**ADDENDUM NO. 1
NEW ELEVATOR
AT MURPHY ELEMENTARY SCHOOL
ROUND LAKE SCHOOL DISTRICT NO. 116
PROJECT NO. 23170**

Board of Education
Round Lake School District 116
884 West Nippersink Road
Round Lake, Illinois 60073

2 PARTIAL FIRST FLOOR PLUMBING PLAN
 1/4" = 1'-0"

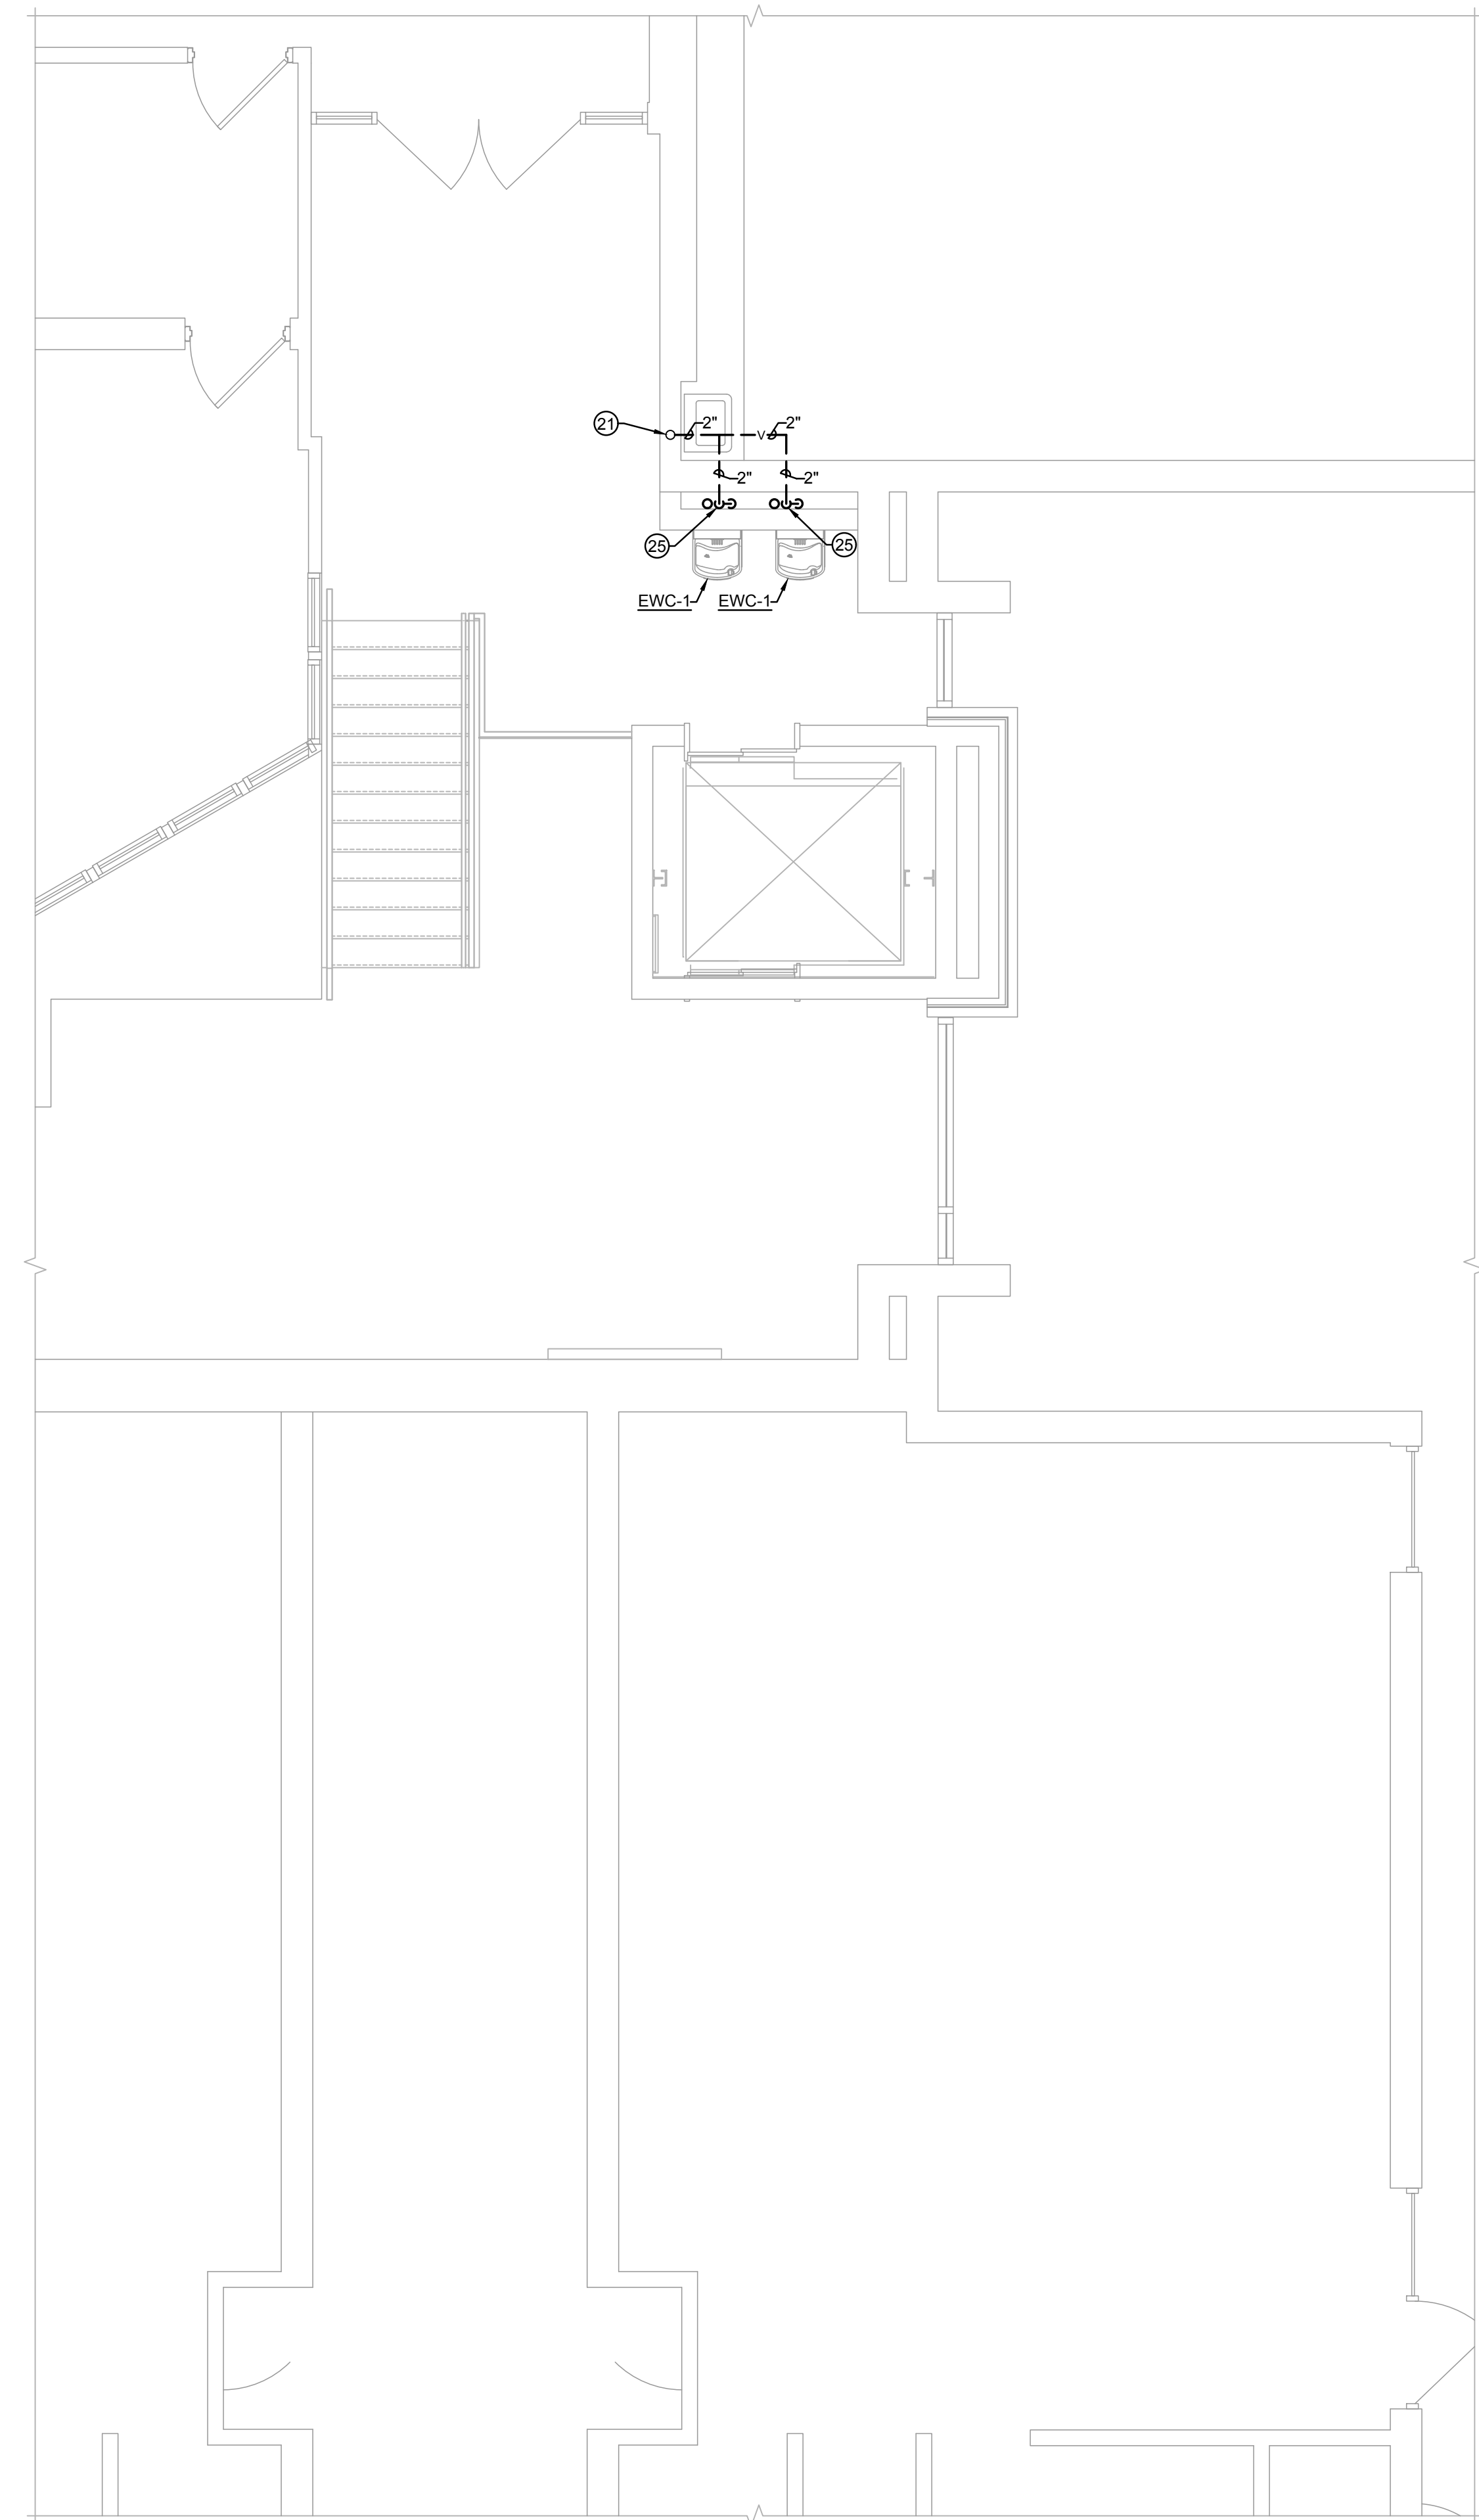
ITEM NO. 8: PROJECT DRAWINGS, P1.0, PARTIAL PLUMBING PLANS

1. Refer to attached drawing P1.0 and refer to highlighted items for updates.

E0.1

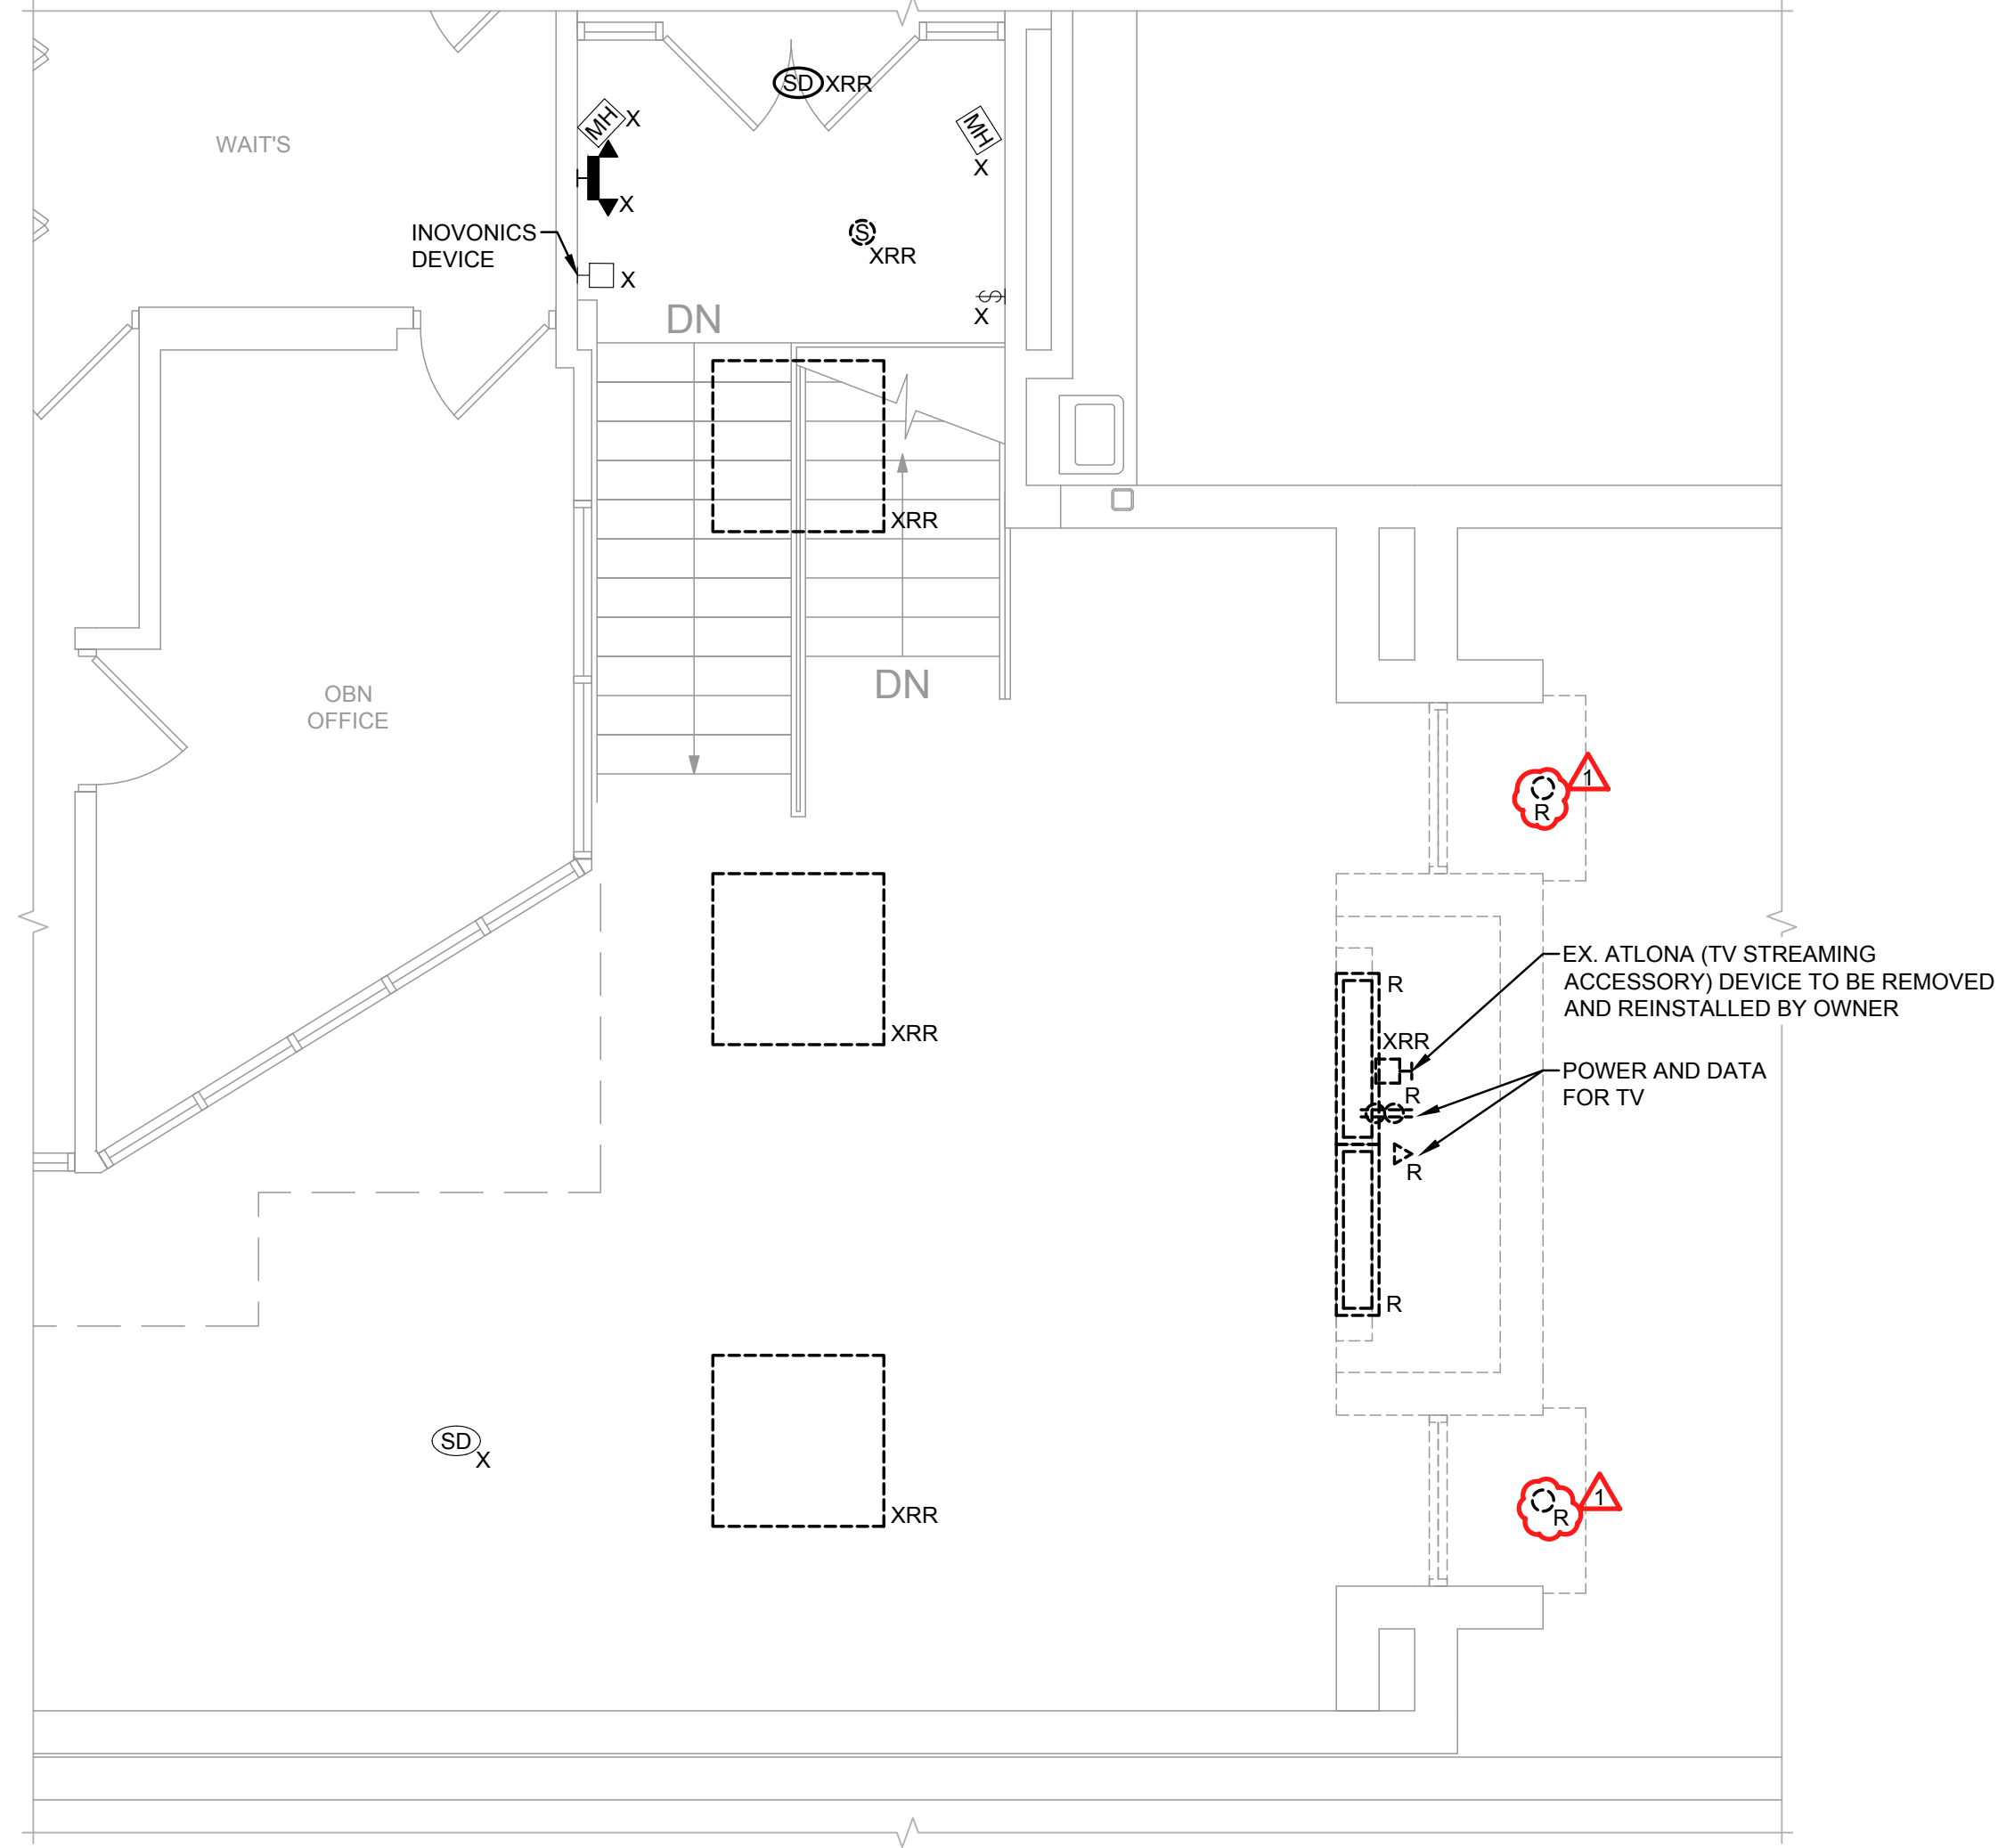
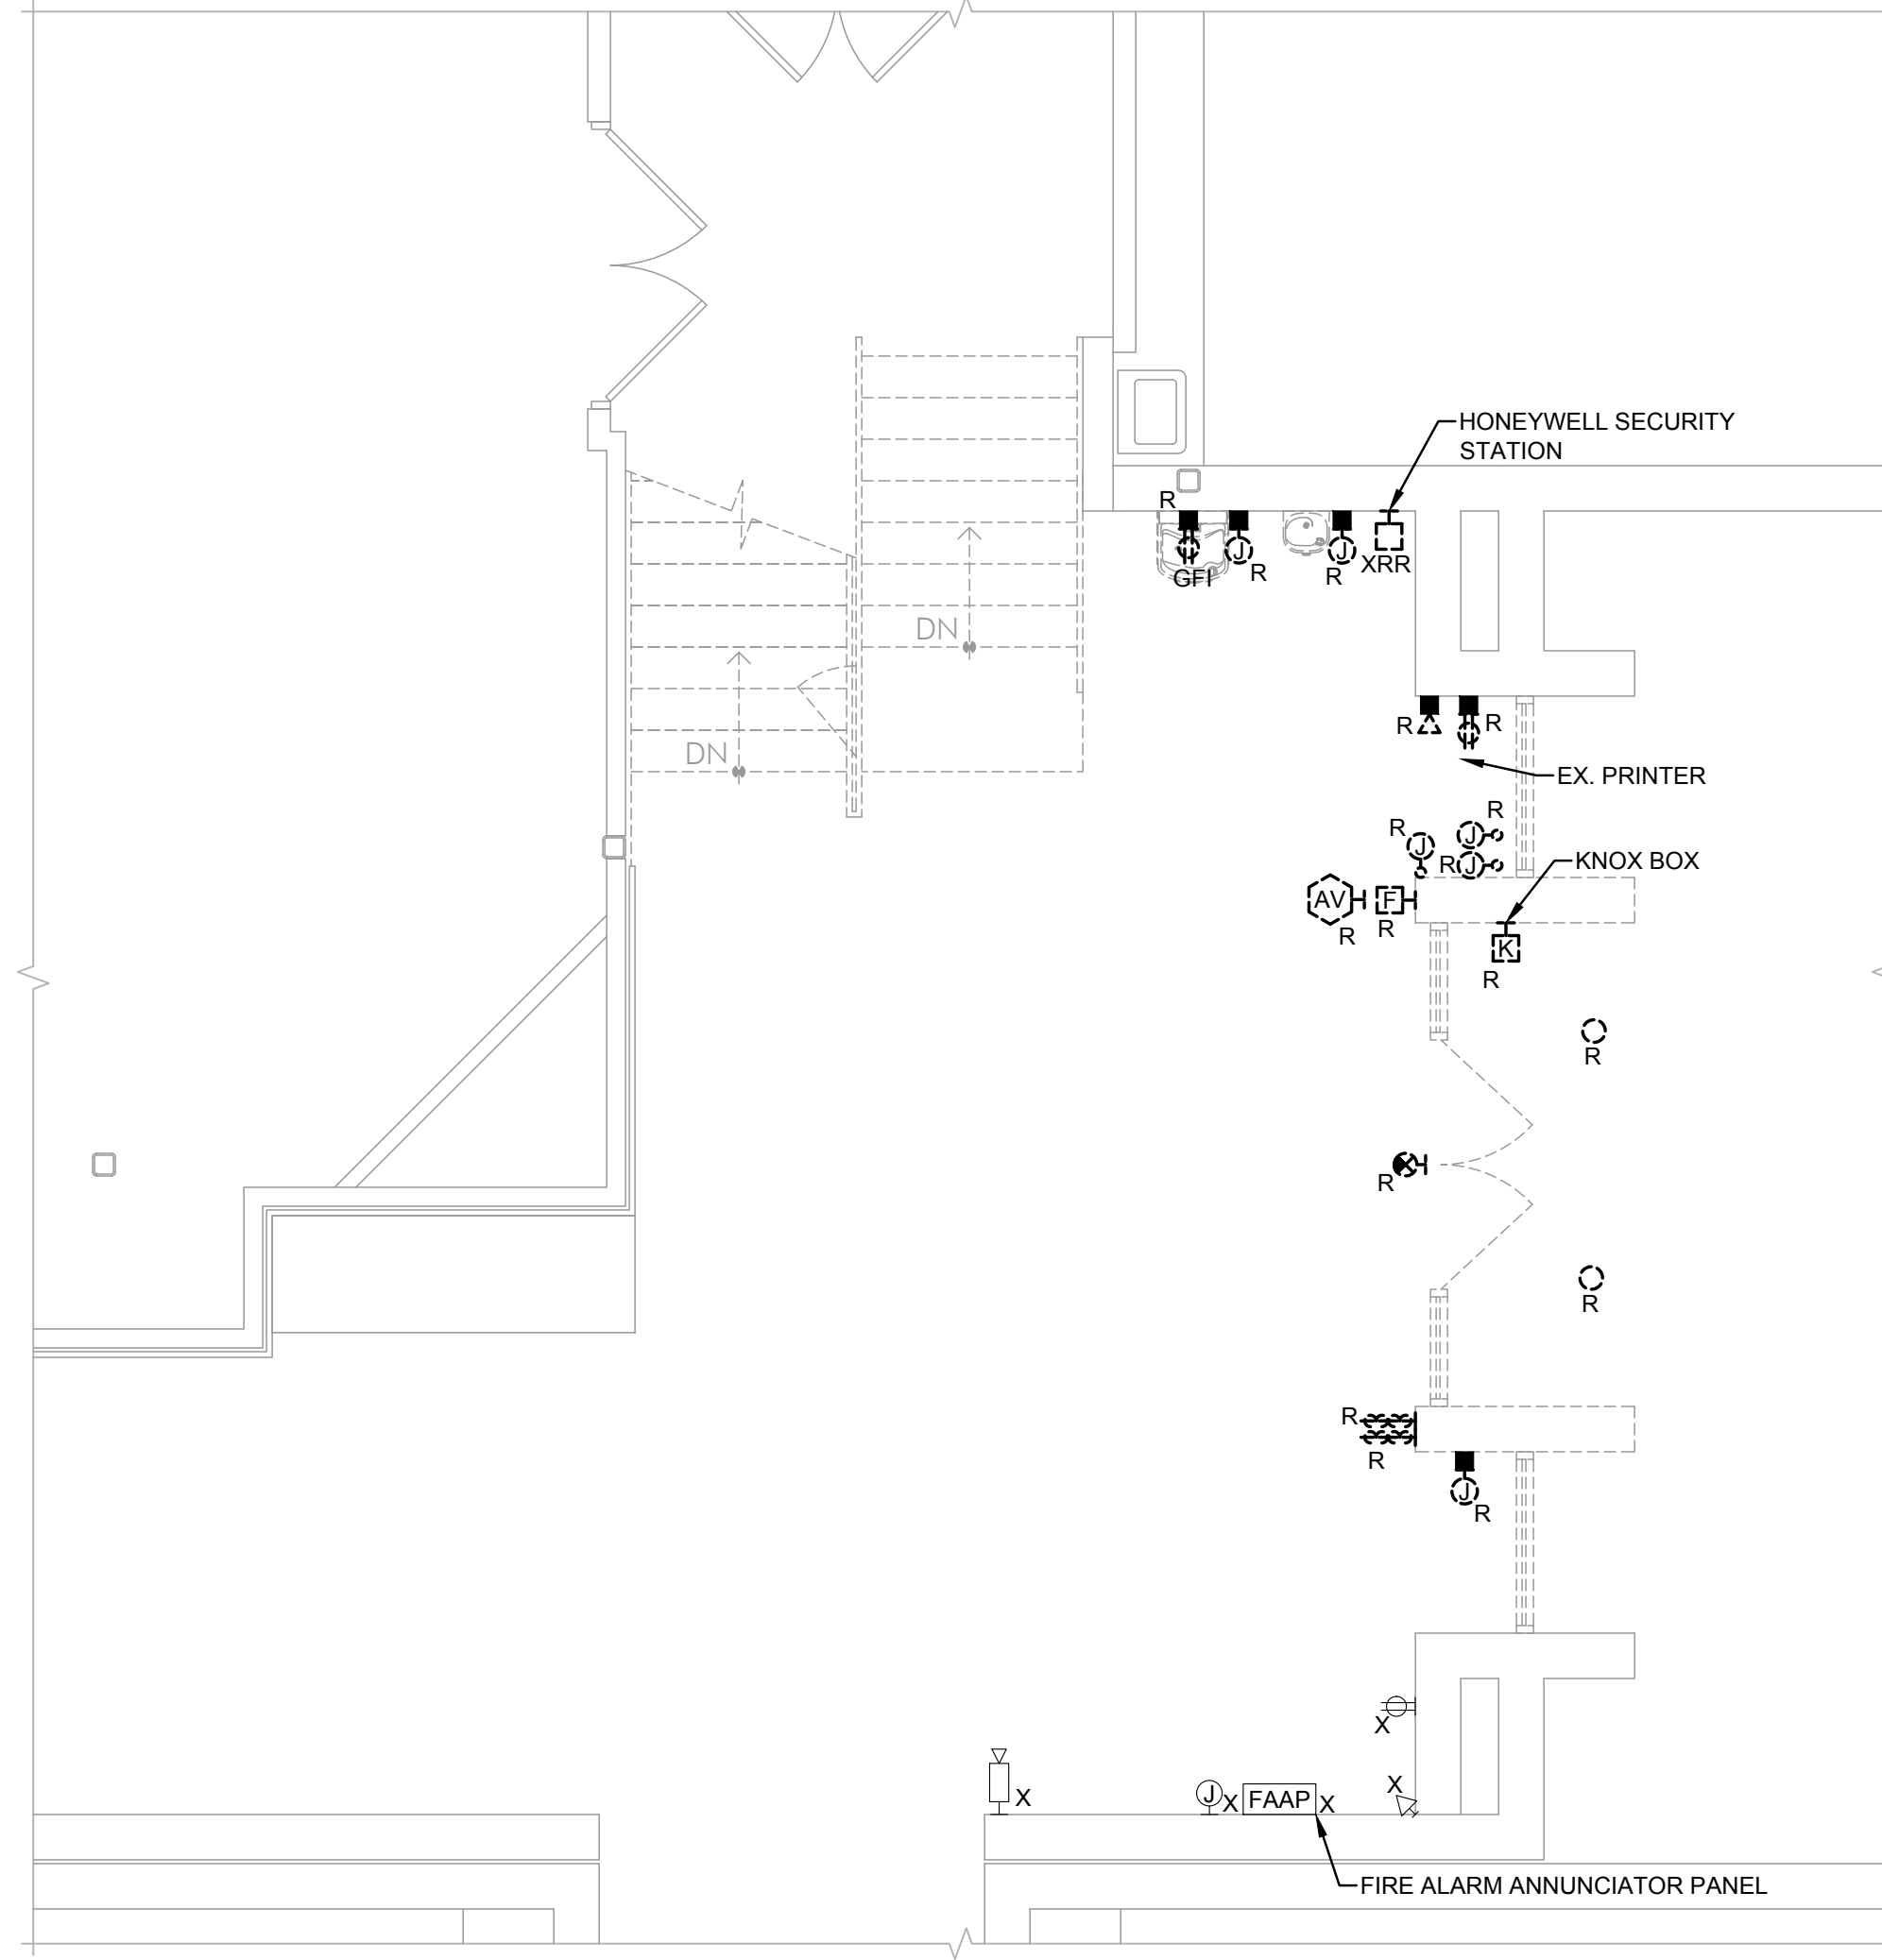
ITEM NO. 9: PROJECT DRAWINGS, E0.1, PARTIAL ELECTRICAL DEMOLITION PLANS

1. Refer to attached drawing E0.1 and refer to highlighted items for updates.
